ASHLAND/NORTHERN STATES POWER LAKEFRONT SUPERFUND SITE

Constructability Review -- Re: EPA Proposed Plan (June 2009)

August 17, 2009

Northern States Power Wisconsin

**ASHLAND PROJECT
ESTIMATED EFFECTIVE STRESSES IN MILLER CREEK
AQUITARD WITH VARIOUS REMOVAL SCENARIOS**

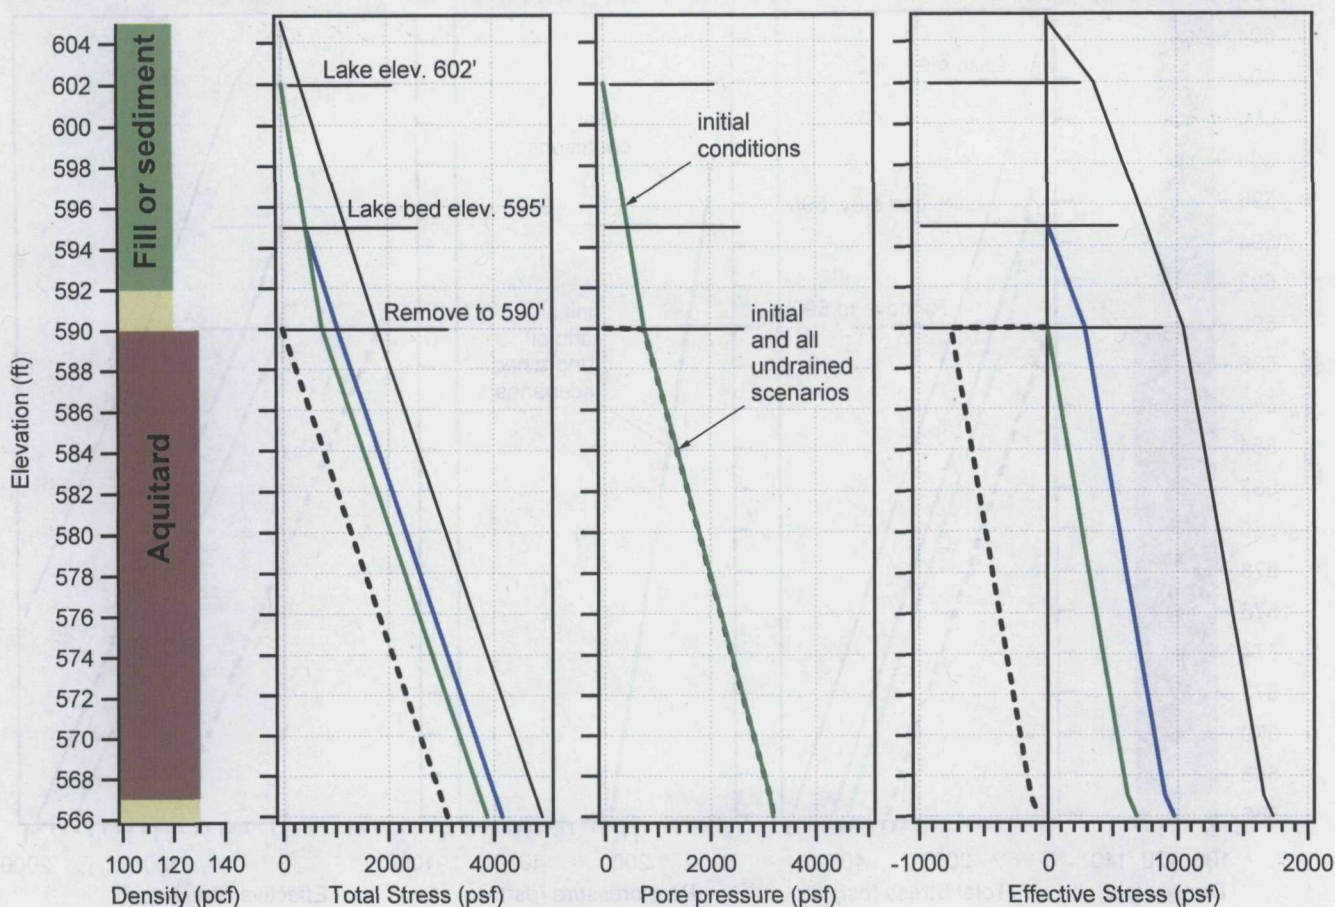
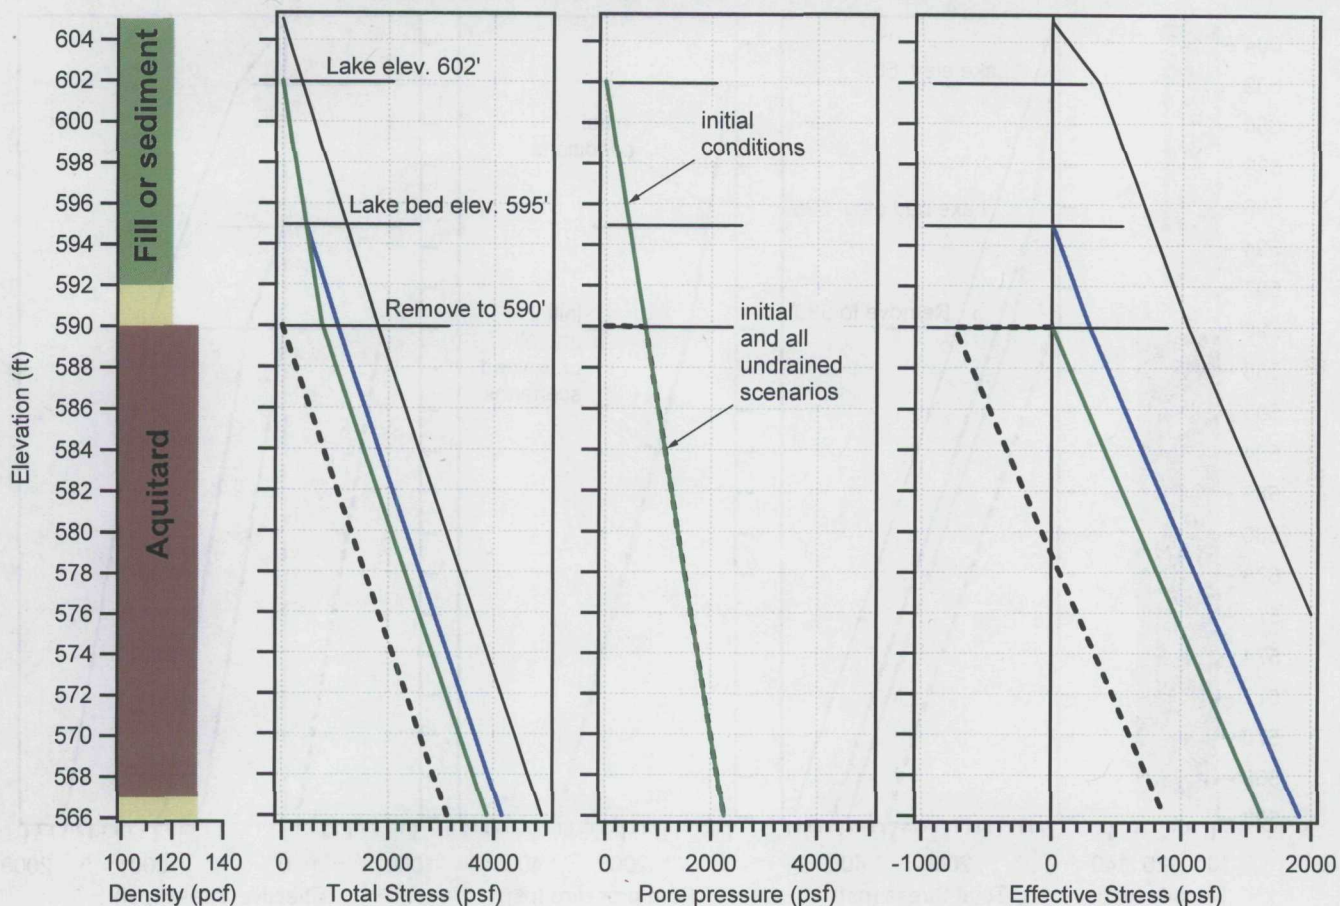
The information and conditions provided in the documents referenced above establish a likely uplift, or basal heave condition where the upward pressure condition at the base of the aquitard exceeds the downward pressure due to the density of the unexcavated materials of the Miller Creek Formation. The calculations provided in this referenced figure are appropriate for the given conditions.

- The “base” condition established by Foth and presented in the referenced figure provides a net uplift (heave condition) of 136 pounds per square foot (psf), for a factor of safety against heave of 0.96.

As mentioned above, the result of a negative effective stress at the top of the aquitard for the hybrid removal option is not unexpected. This result would occur even without artesian conditions, as is shown in Figure 2. Here, the head at the base of the aquitard is set at the lake elevation, and the pore pressure at the base of the aquitard is 2184 psf, nearly 1000 psf lower than the artesian condition. The effective stress at the top of aquitard is the same (-750 psf), but effective stresses increase to positive values at depth within the aquitard.

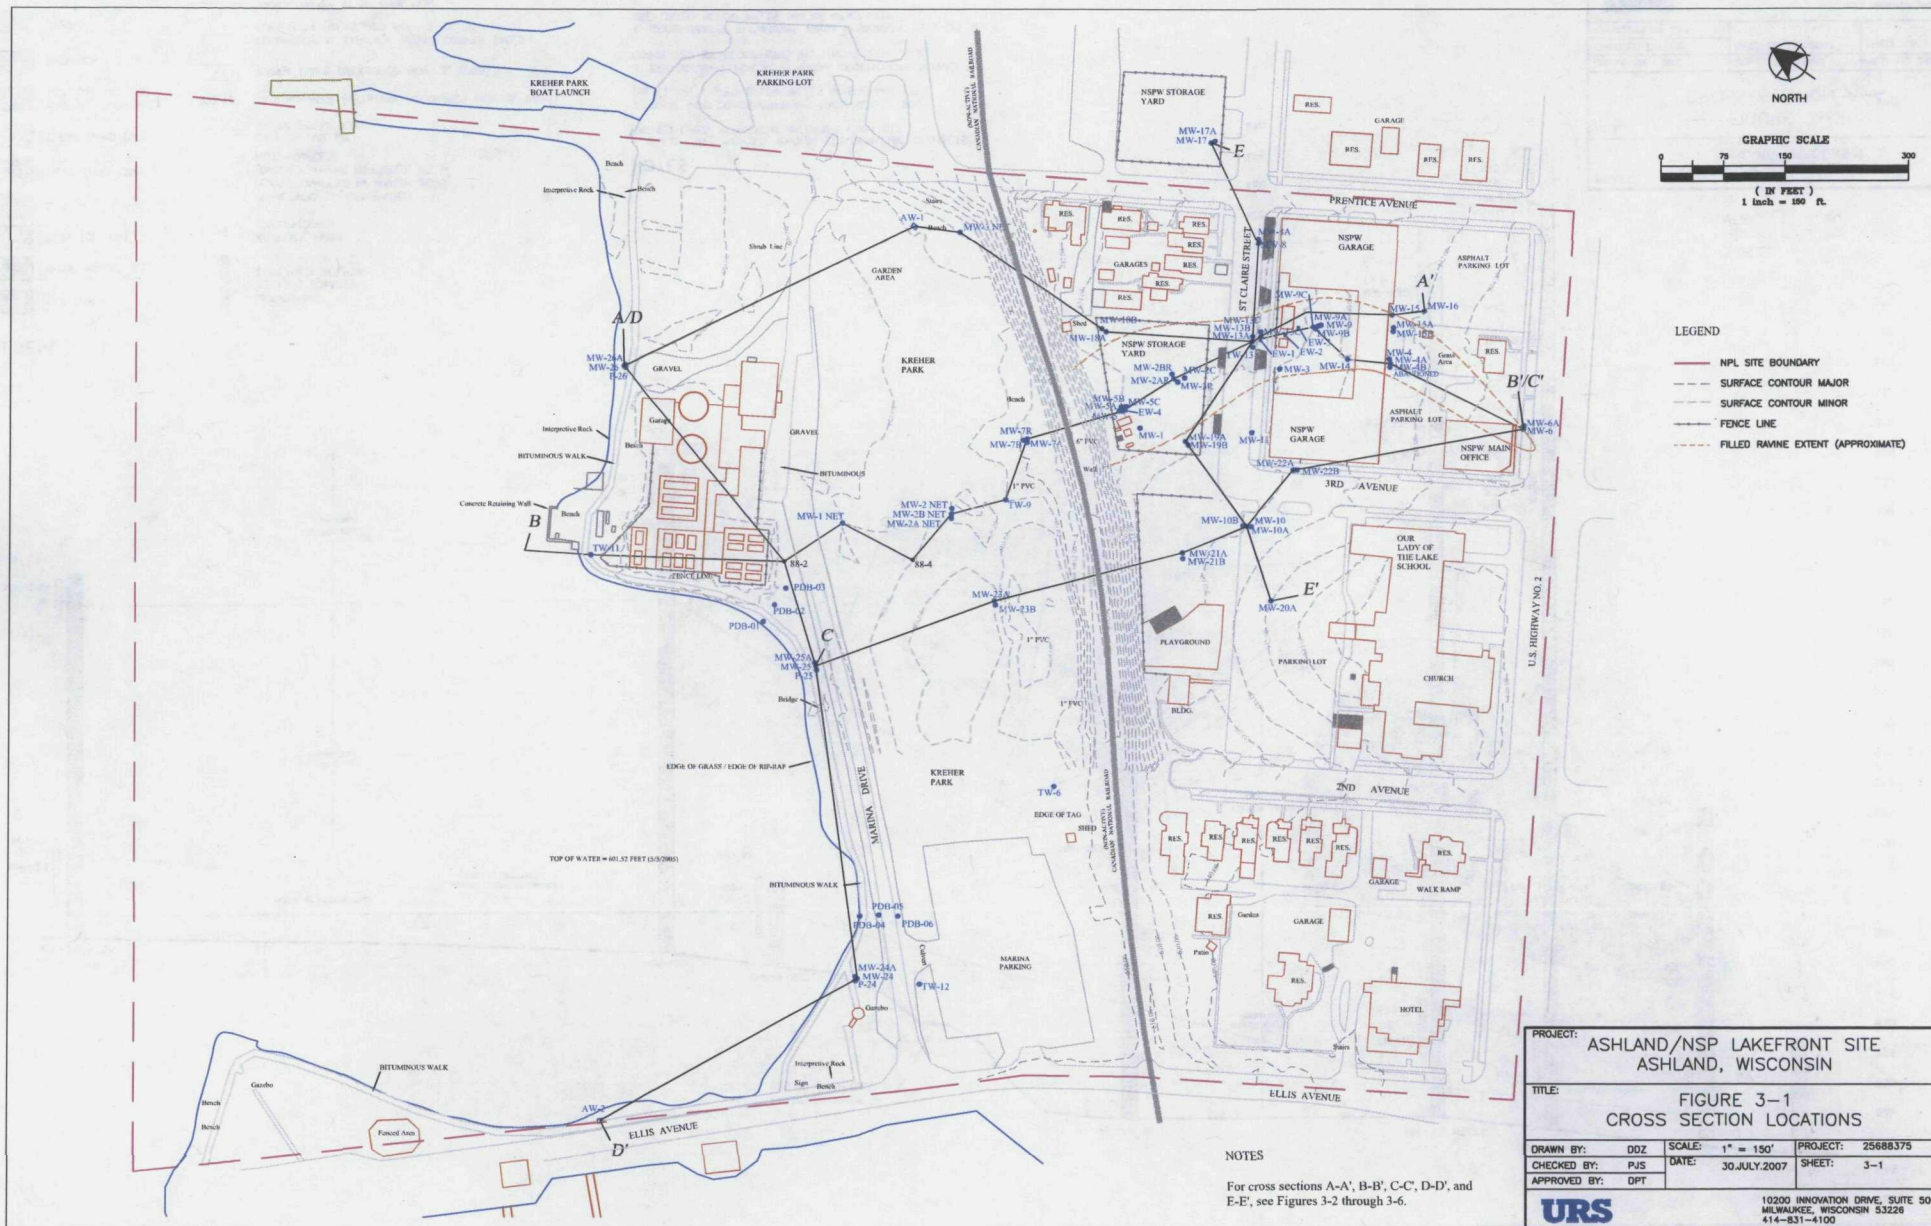
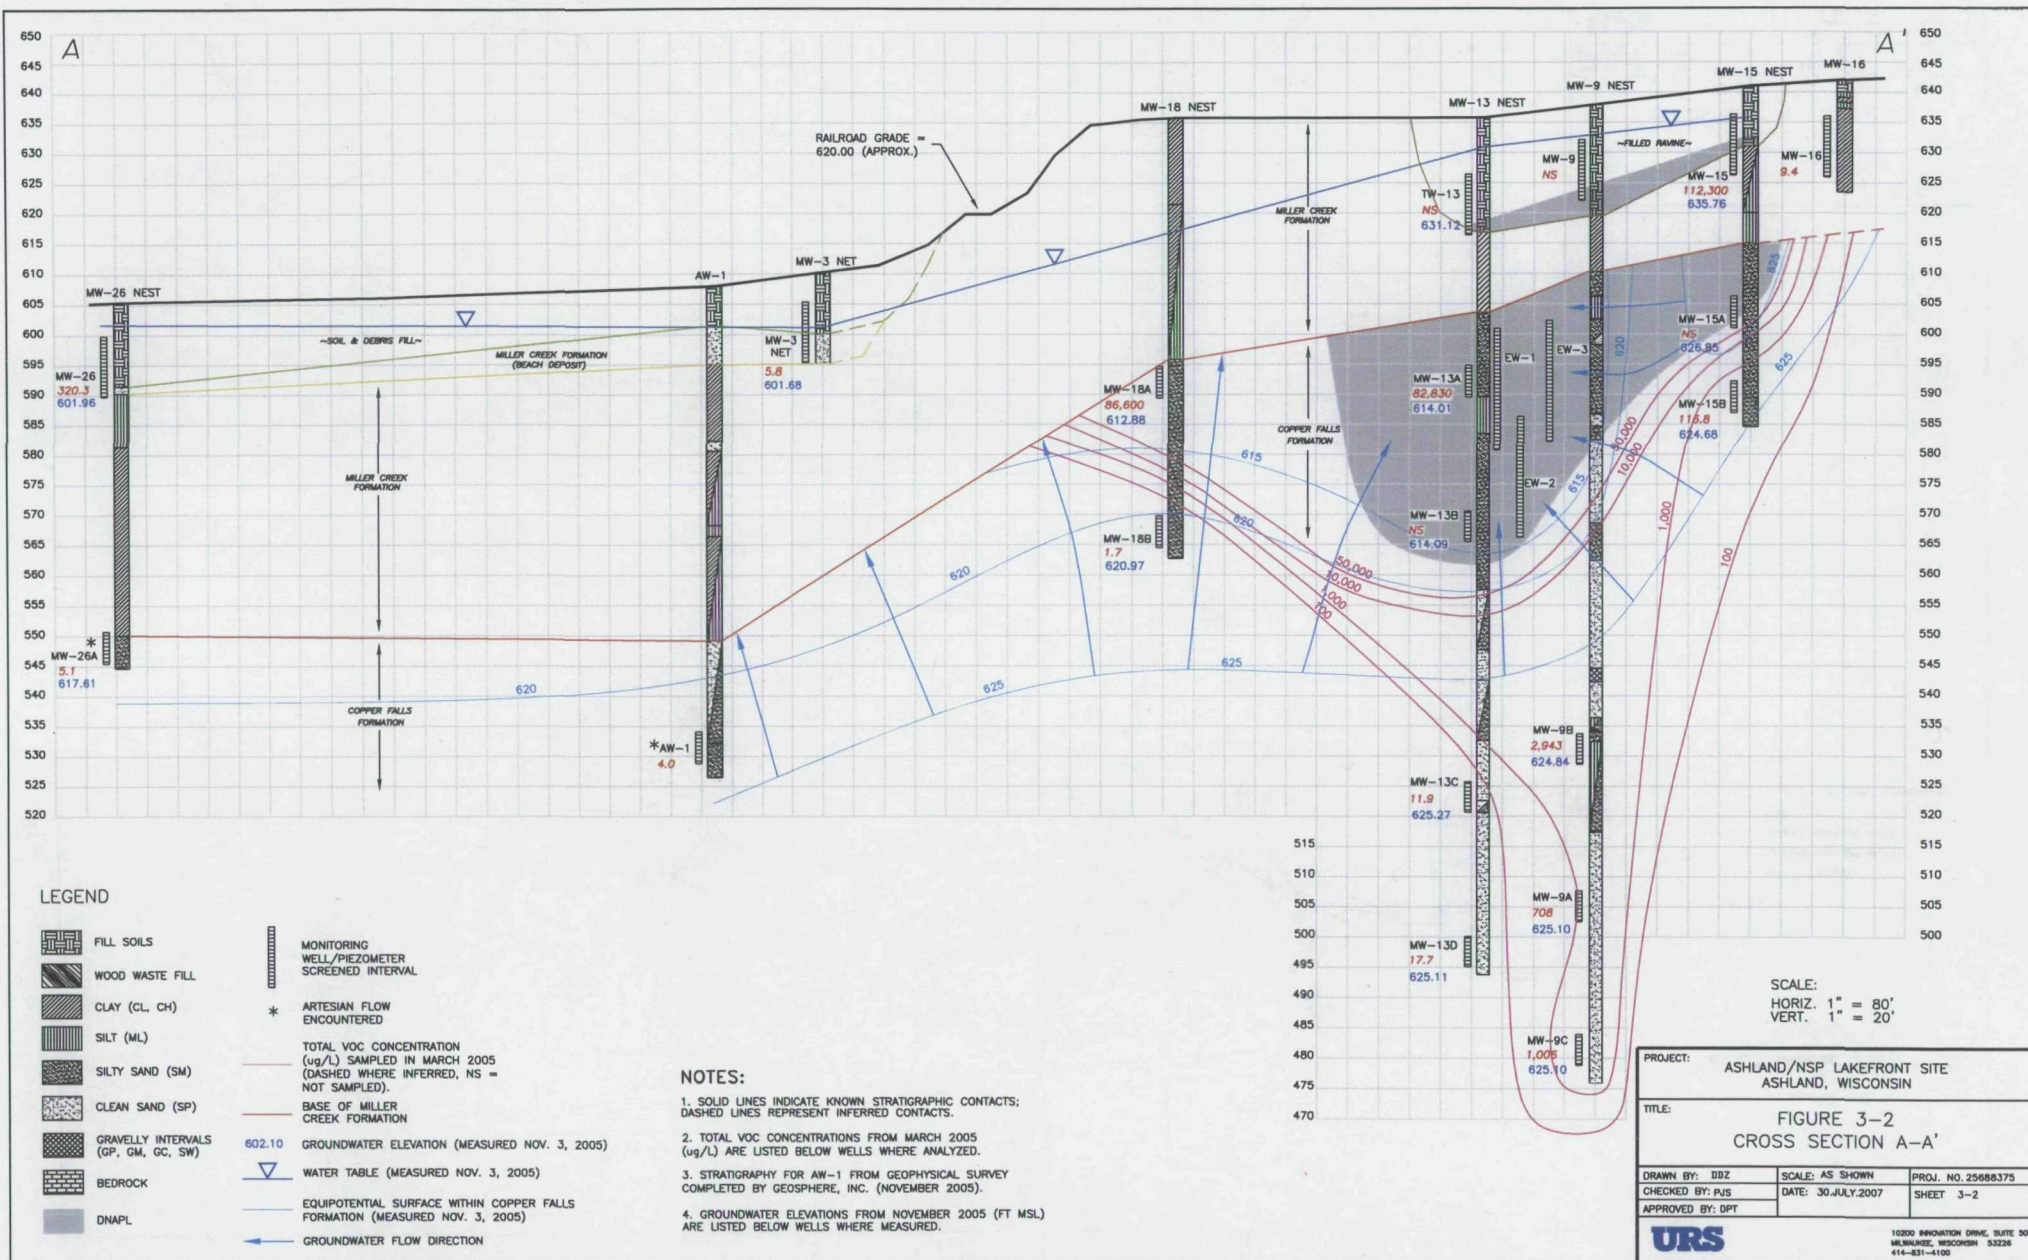
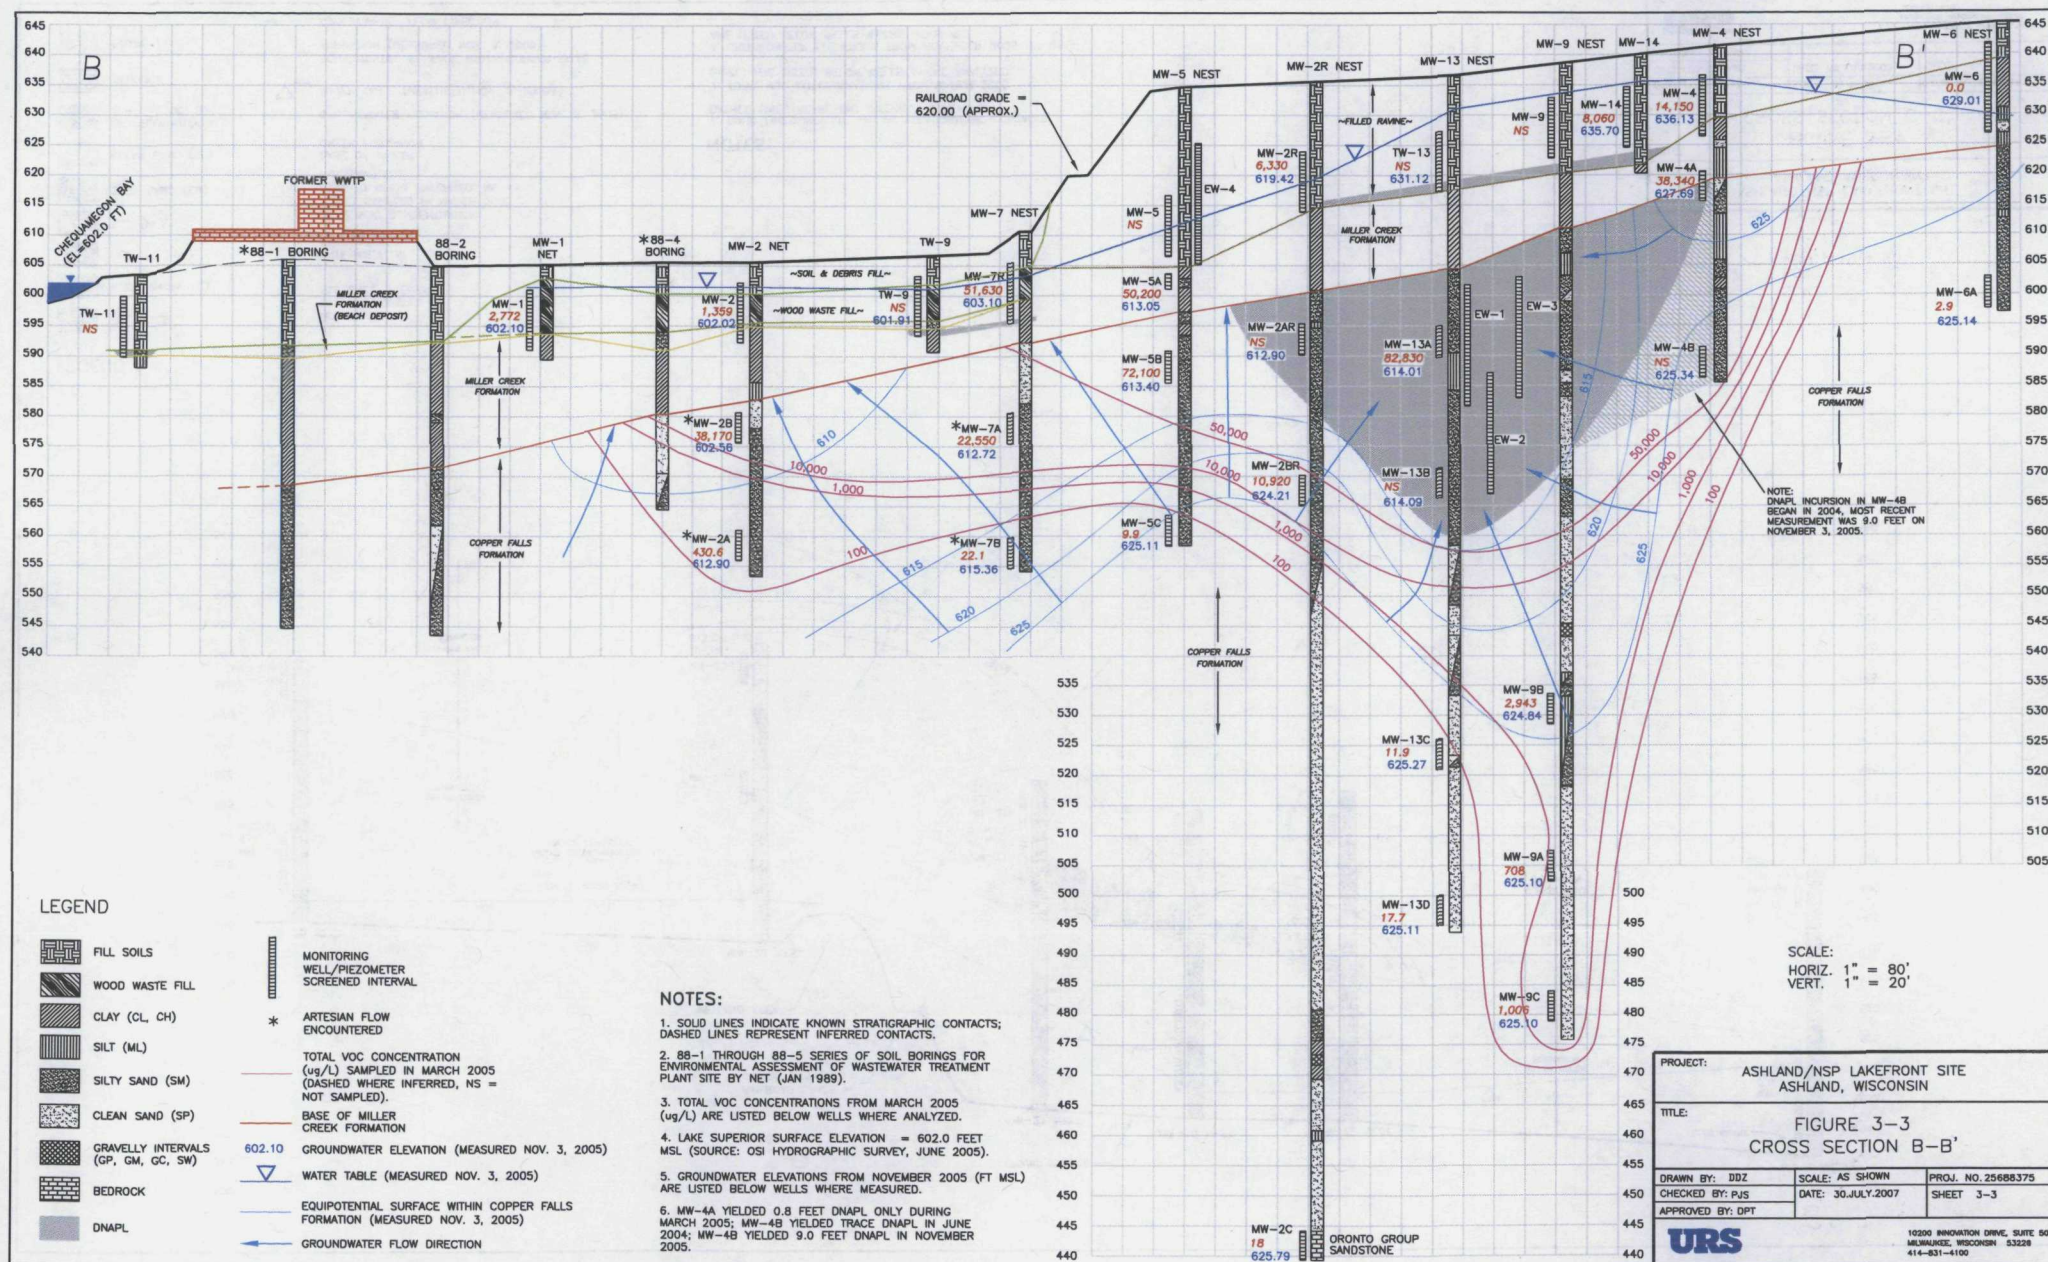
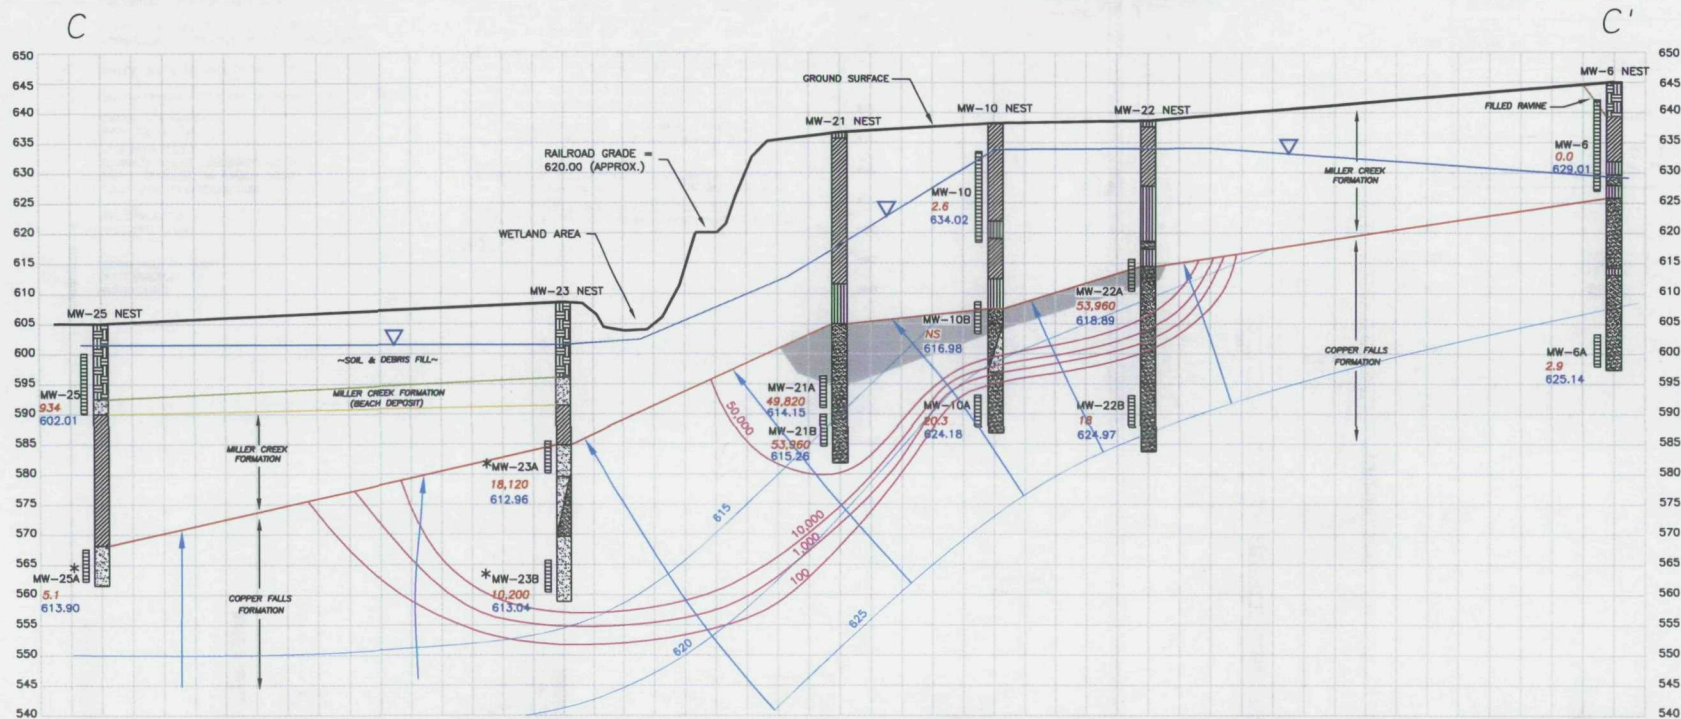
$$\begin{aligned}
 \text{Artesian Force (H}\uparrow\text{)} &= (617 \text{ ft} - 567 \text{ ft}) \times 62.4 \text{ lb/ft}^3 \\
 &= 50 \text{ ft} \times 62.4 \text{ lb/ft}^3 \\
 &= 3,120 \text{ lb/ft}^2
 \end{aligned}$$

$$\begin{aligned}
 \text{Effective Stress} &= D\downarrow - H\uparrow \\
 &= 2,990 \text{ lb/ft}^2 - 3,120 \text{ lb/ft}^2 \\
 &= \mathbf{-130 \text{ lb/ft}^2}
 \end{aligned}$$

Artesian Force > Downward Force => Basal heave failure
